**Review of the Revised Plan for
Off-Site Treatment of Newport
Chemical Agent Disposal Facility's
Caustic VX Hydrolysate at DuPont
Secure Environmental Treatment
Facility in Deepwater, New Jersey**

A Report to Congress

**Department of Health and Human Services
Centers for Disease Control and Prevention**

July 2006

Figure 1. Removal Efficiency of the DuPont Revised Process

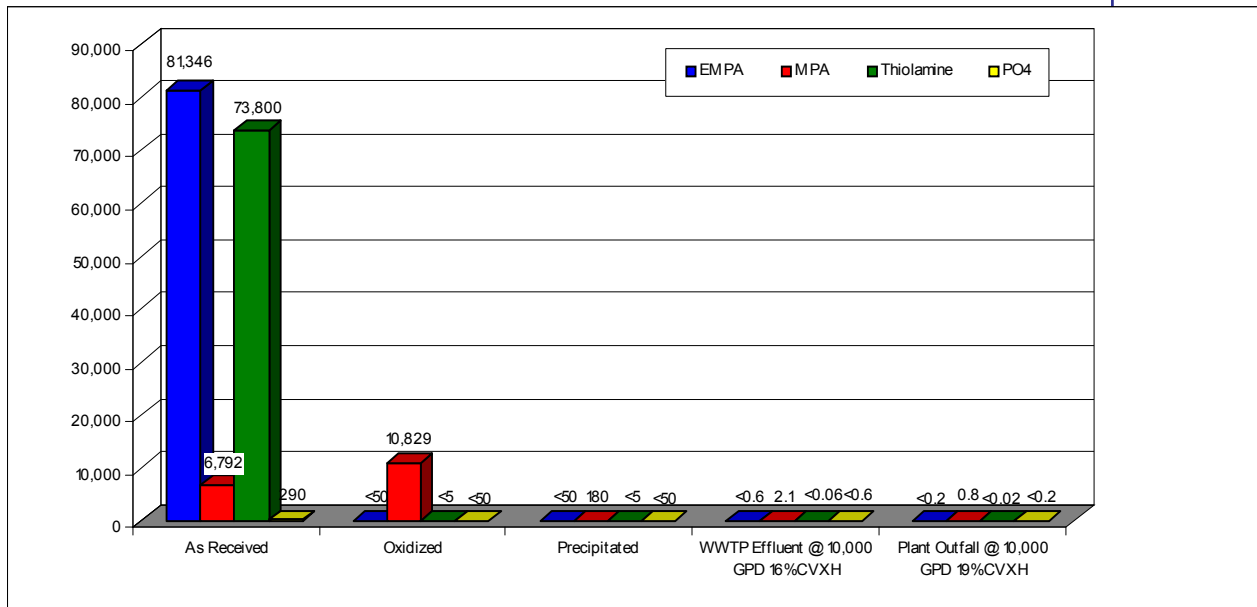
- The DuPont combined pretreatment studies demonstrate that 16% VX loaded CVXH DIC, DCC, and DIC/DCC stabilized hydrolysate can be effectively treated to remove phosphonates (EMPA and MPA) before biotreatment. The results of the testing are shown in Figure 1 (5).
